SERVICE BULLETIN No. RTC-040a R11

- 1. CONCERNING TO:** All SportStar RTC aircraft.
- 2. REASON:** Revision of Chapter 02 and 07, and inclusion of Supplement No. 44 into the List of Supplemnts in Chapter 09 of the Pilot's Operating Handbook, doc. No. ERTC019-10-AS / ERTC020-10-AS for the SportStar RTC aircraft.

Doc. No. ERTC020-10-AS

Figure 7–8 Stall speed vane on the left wing

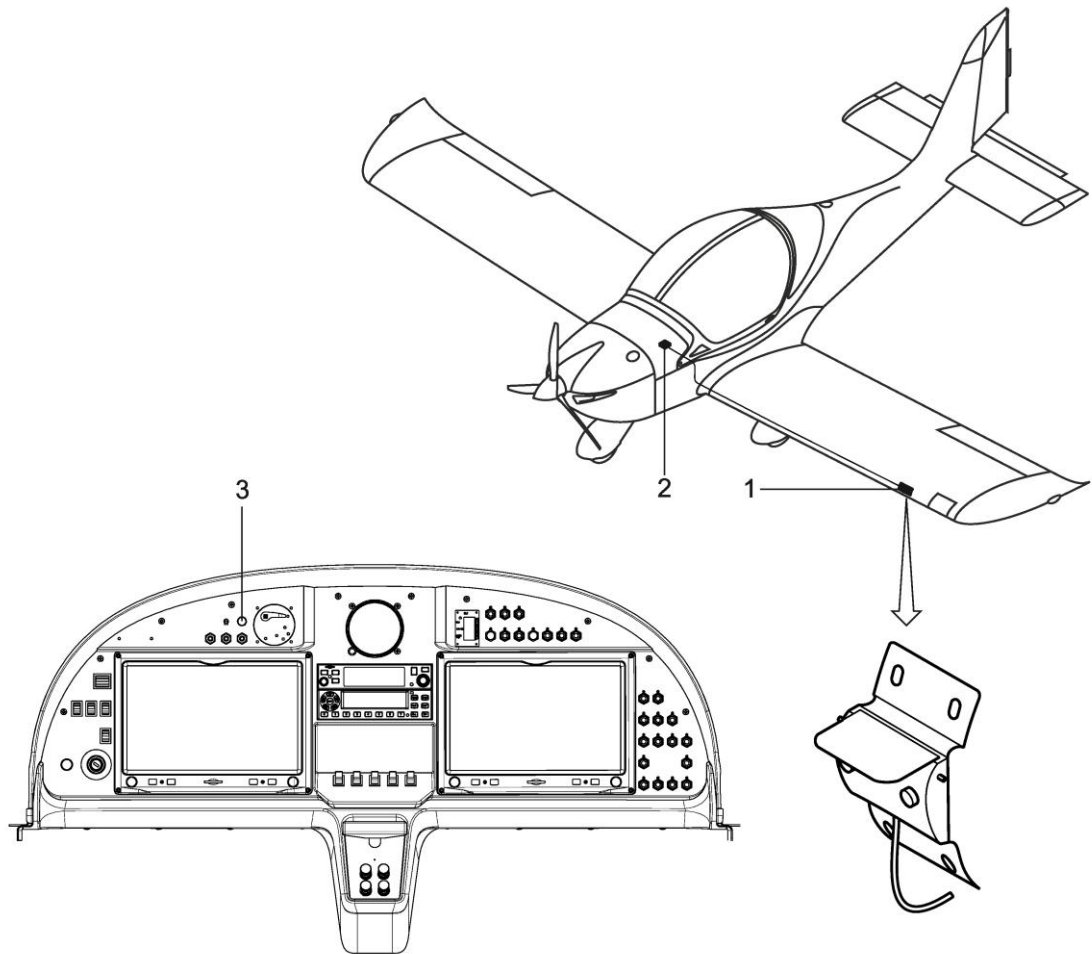
Stall warning system ACI type T1 is installed on this airplane to warn pilot that airspeed is decreasing near to stall.

Stall speed vane (sensor) is located on the left wing, audible alarm box is located in the cockpit (behind the instrument panel).
